To: Kristopher Byrd, Well Construction and Compliance Section Manager
From: Travis Kelly, Well Construction Program Coordinator
Subject: Review of Water Right Application G-19157
Date: July 6, 2021

Application # G- 19157

TO: Water Rights Section Date 06/29/2021
FROM: Groundwater Section Phillip I. Marcy Reviewer's Name
SUBJECT: Application G- 19157 Supersedes review of Date of Review(s)

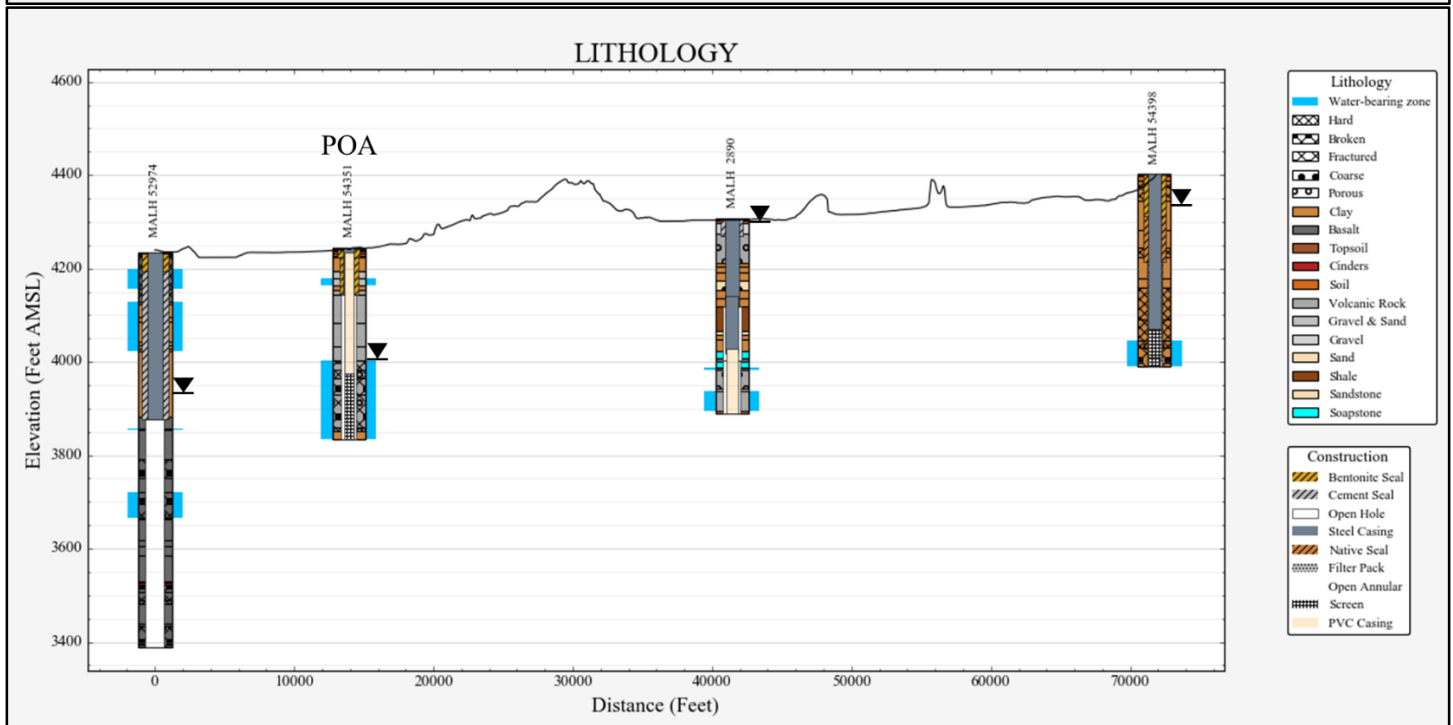
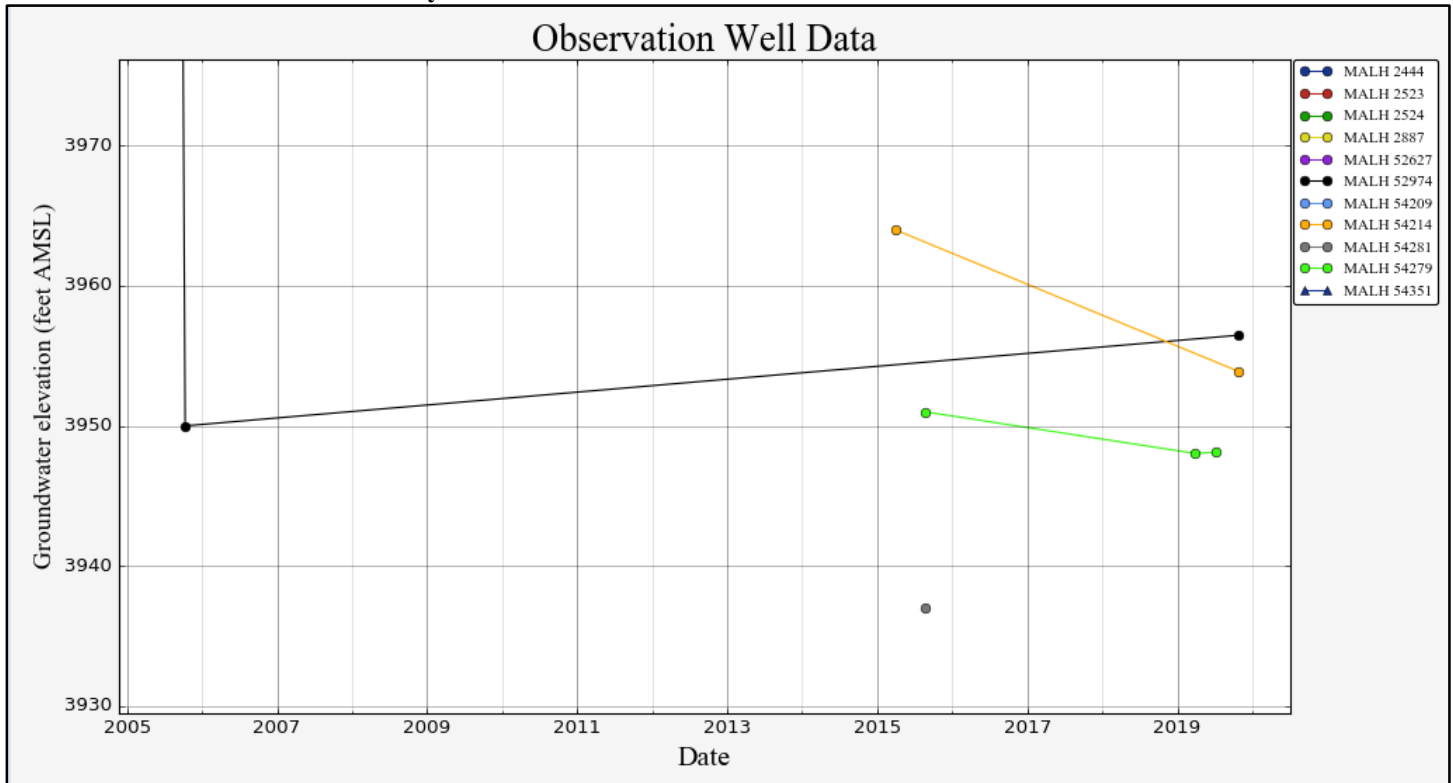
D2. **THE WELL does not appear to meet current well construction standards based upon:**

- a. review of the well log;
- b. field inspection by _____;
- c. report of CWRE _____;
- d. other: (specify) _____

D4. **Route to the Well Construction and Compliance Section for a review of existing well construction.**
